PEARSON FARMS ADDITION

Re: Final Plat S/D 88-24 - PEARSON FARMS ADDITION

STAFF REPORT
(Final Plat; Preliminary Approved 4/21/88)

CASE NUMBER: S/D 88-24 - PEARSON FARMS ADDITION

FINAL PLAT

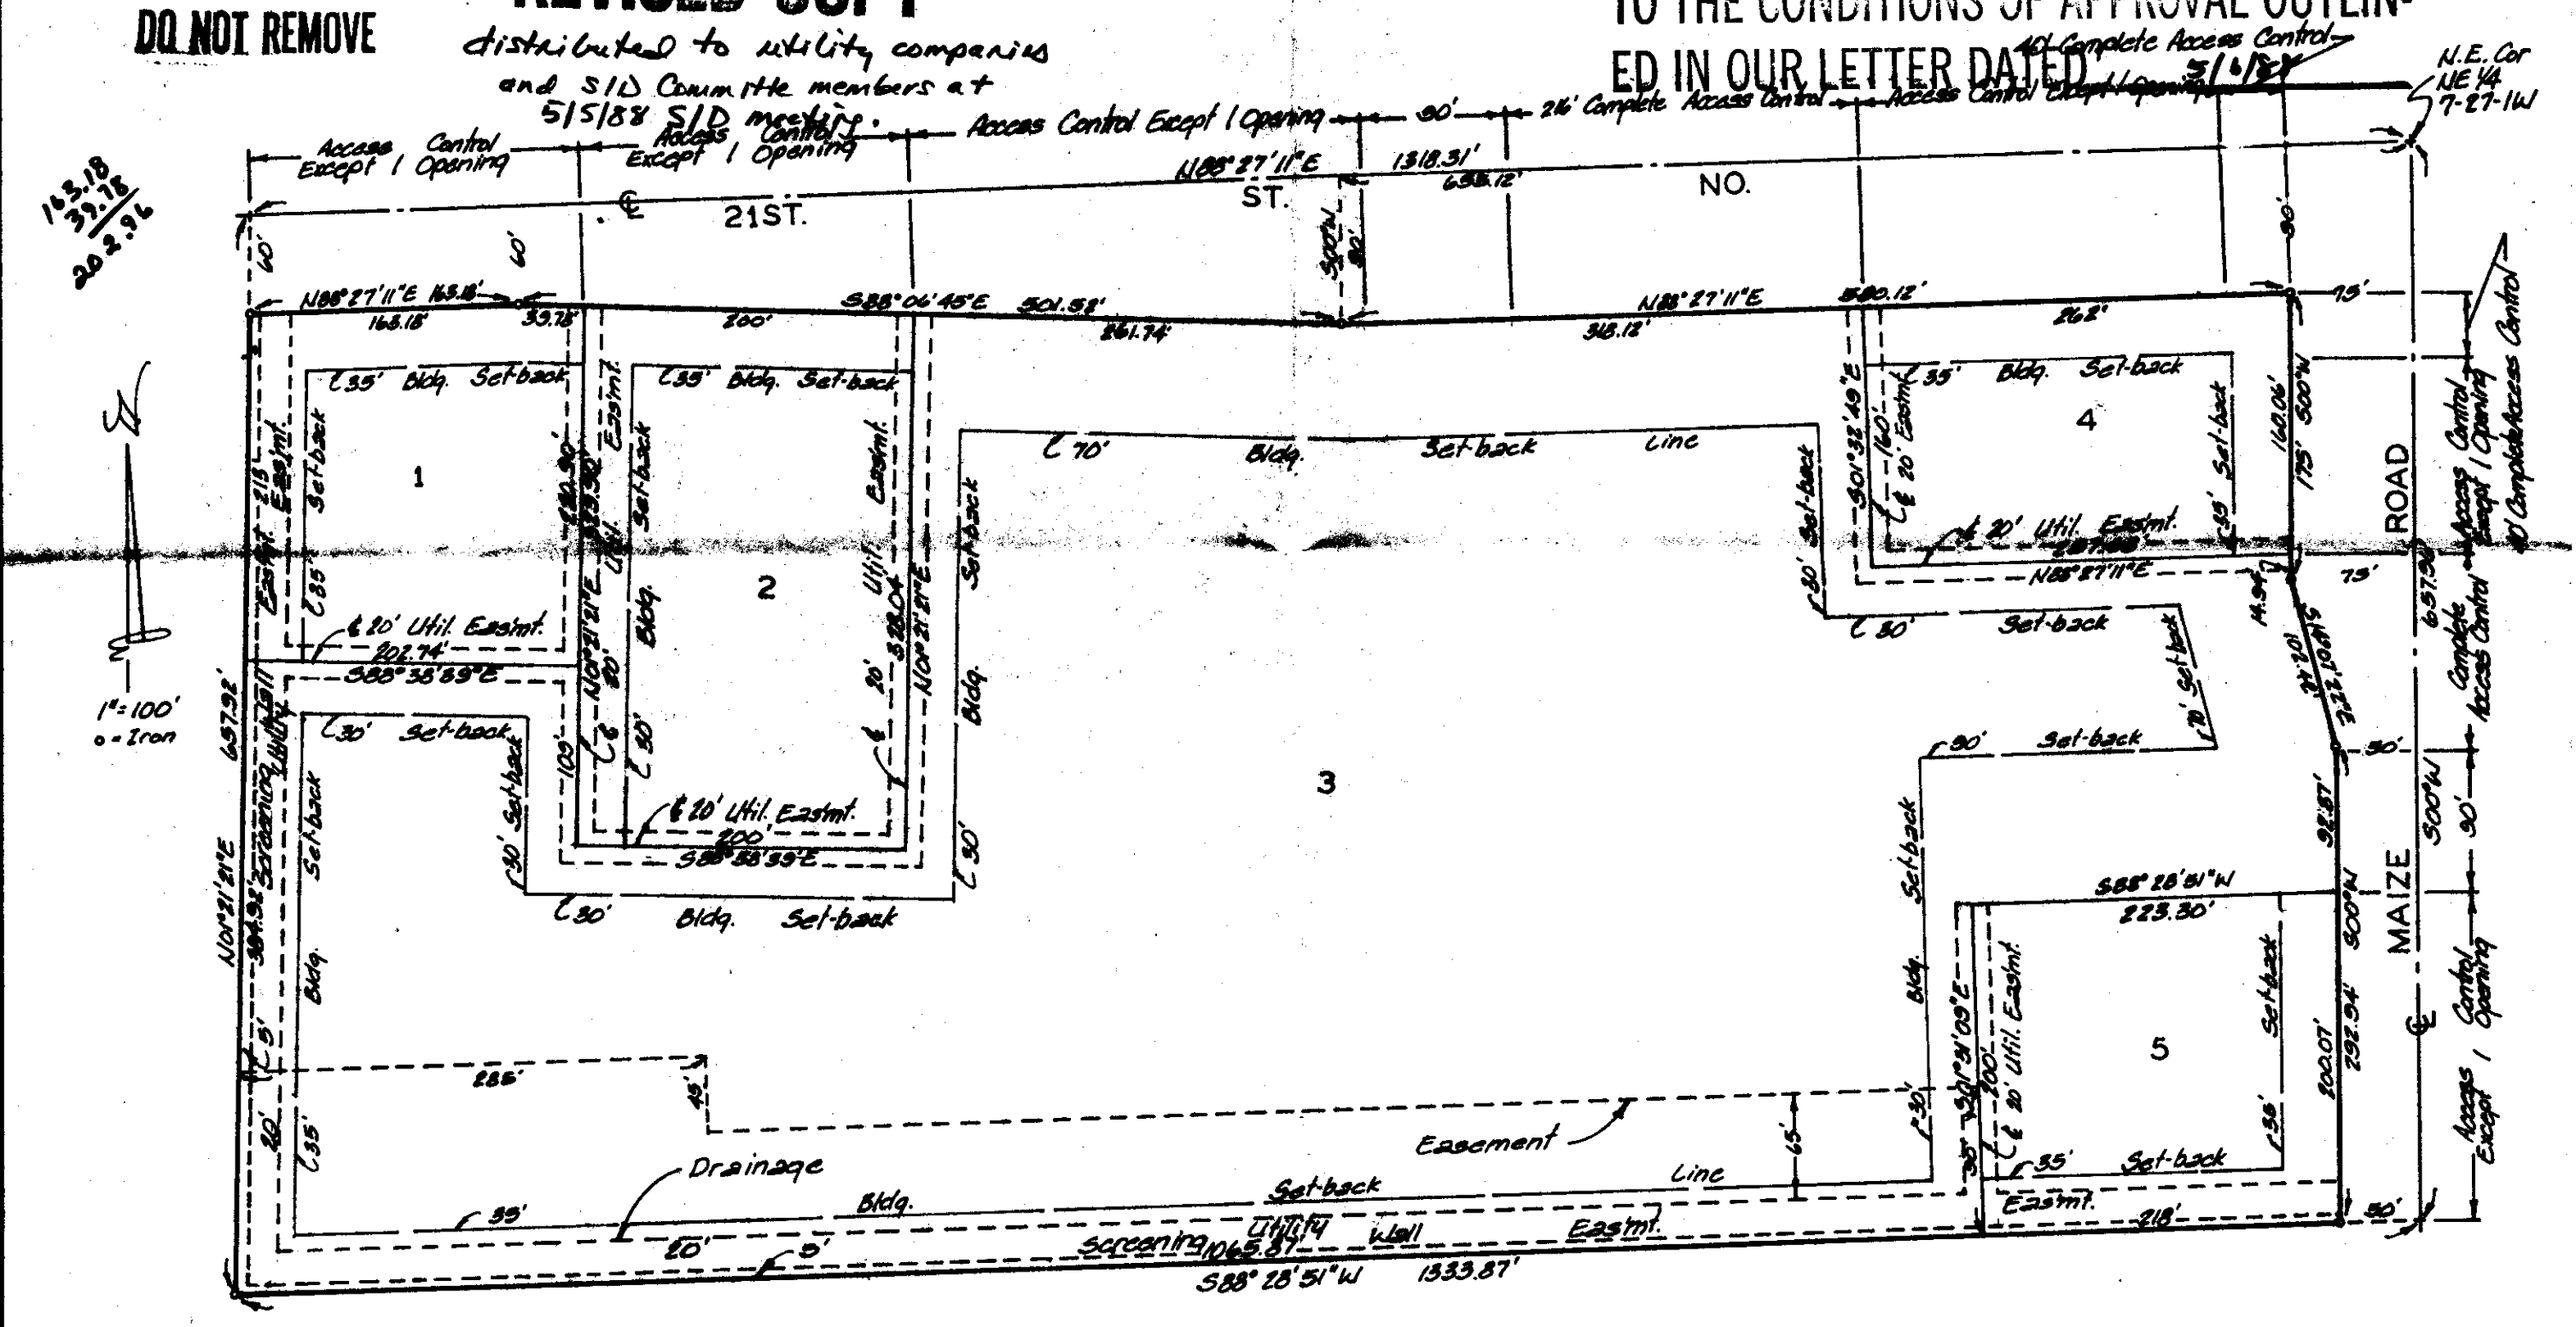
J. As required by the drainage plan for this property, the applicant shall submit a cross lot drainage agreement. This agreement shall provide for Lot 5 to drain across Lot 3.

L. The final plat tracing shall indicate the utility easements requested by K.G.&E. and Southwestern Bell. These easements are indicated on the surveyor's copy of the approved preliminary plat.

N. On the final plat tracing, the plattor's text shall be amended to more clearly indicate the access openings being allowed from the lots to Maize Road and 21st Street. In particular, the 90-foot areas from Lot 3, intended for major entrances, needs to be more accurately described. It is suggested that the plattor's text simply state that, "access controls as depicted on the face of the plat are hereby dedicated". Also, the 90-foot wide areas on Lot 3 should be labeled on the face of the plat as areas of "access control except for one opening".

O. On the final plat tracing, the perimeter of Lot 2 shall be reduced to match the boundaries of C.U.P. Parcel 2. On the preliminary plat, the configuration of Lot 2 was correctly shown. If the applicant desires to plat Lot 2 as shown on this final plat, an adjustment to the Community Unit Plan parcel descriptions is required.

P. Perimeter closure computations shall be submitted with the final plat tracing. Section 5-101(C).
